Docket No. 50-255
LS05-81-03-051

Enclosed are copies of our draft evaluations of Systematic Evaluation Program Topics XV-1, XV-2, XV-3, XV-4, XV-5, XV-6, XV-7, XV-8, XV-9, XV-10, XV-12, XV-14, XV-15, XV-17, and XV-19. These evaluations are presented in the form of an assessment of design basis accidents and transients. Also included for completeness are copies of the radiological topic assessments (XV-2, XV-12, XV-16, XV-17, XV-19, and XV-20), which were issued for review previously.

SAFETY ASSESSMENT
PALISADES NUCLEAR POWER PLANT
DOCKET NO. 50-255

PART III.1 EVALUATION OF DESIGN-BASIS EVENTS: ACCIDENTS AND TRANSIENTS

Figure 3 Palisades emergency core cooling system (injection mode)

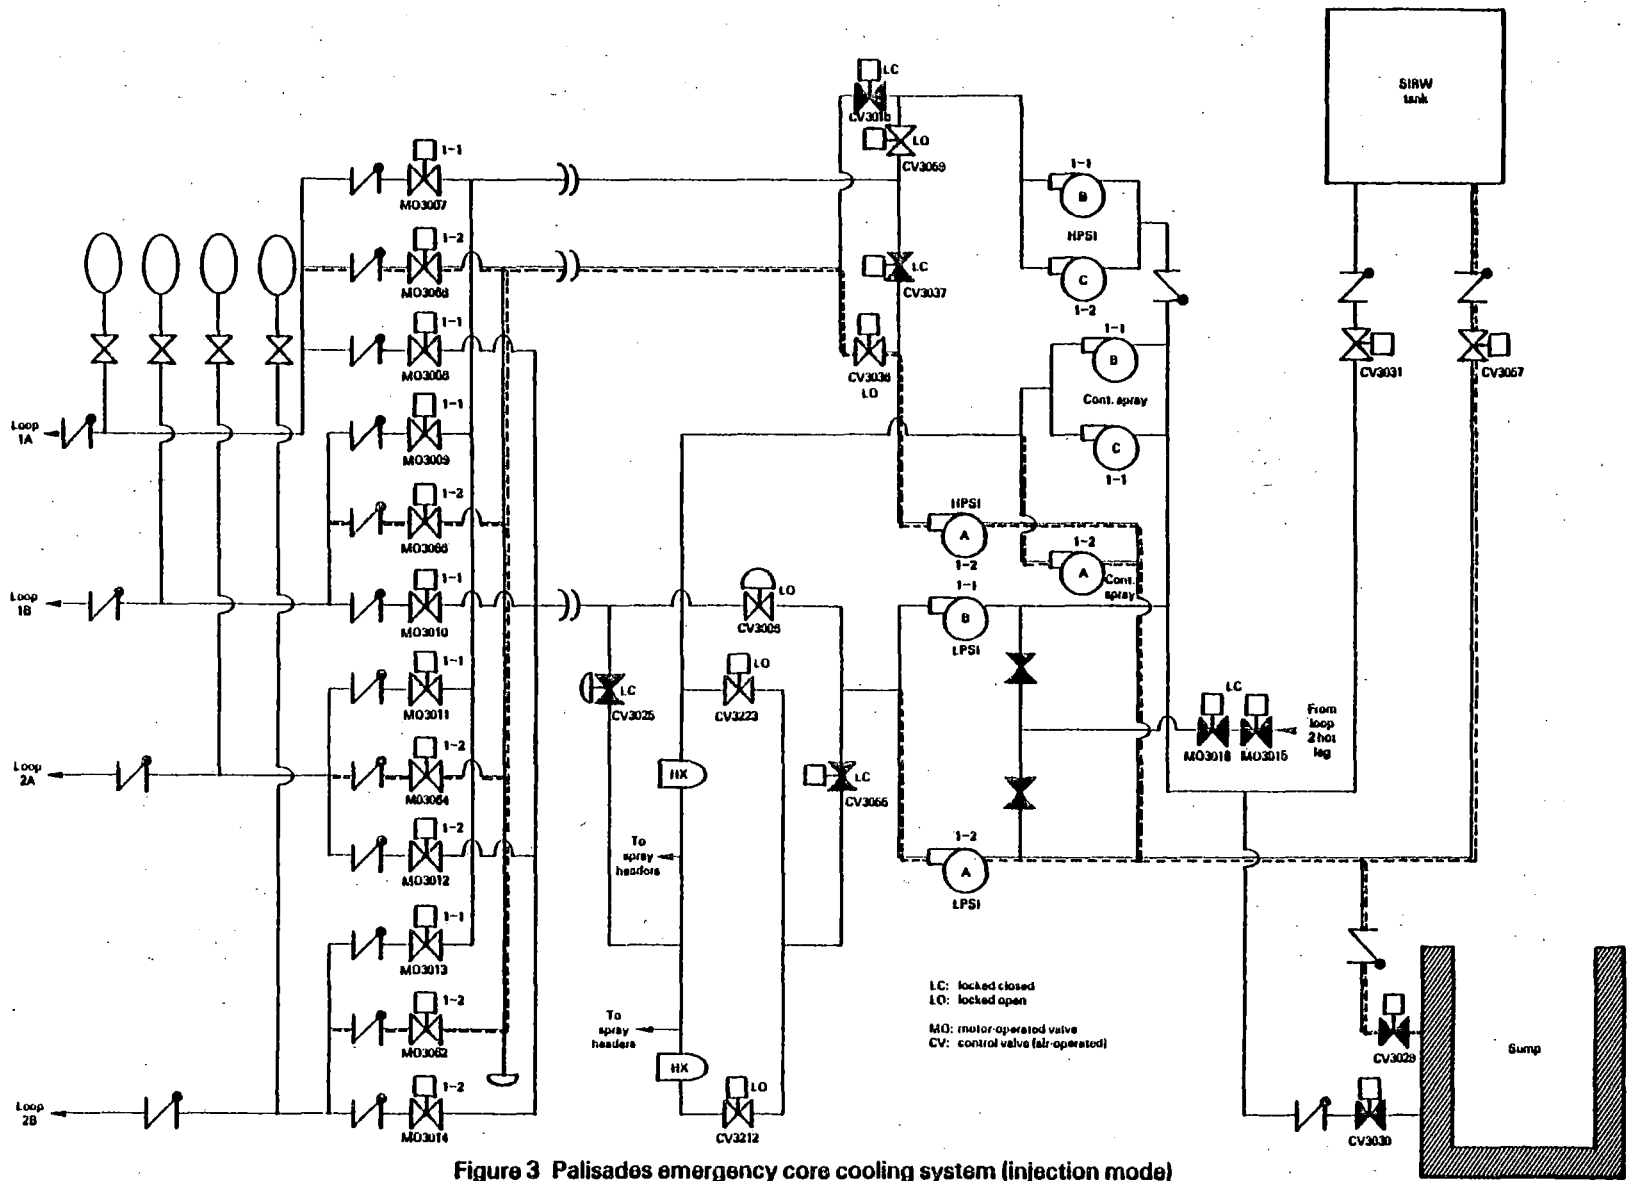
With the present safety injection system configuration (see Figure 3)* a failure of the check valve in an LPST discharge line would, therefore, allow the HPST pumps to overpressurize the LPST system.** The motor-operated LPST discharge valves open automatically on an SIS even if RCS pressure is above LPSI system design pressures as discussed in the safe shutdown review (Topic VII-3), the licensee will be required to install interlocks to prevent opening of the LPSI motor-operated valves until RCS pressure is below LPSI system design pressures. Installation of these interlocks will resolve this concerns.

**This overpressurization could lead to rupture of the LPSI system pressure boundary, and thus insufficient injection flow to the cores.
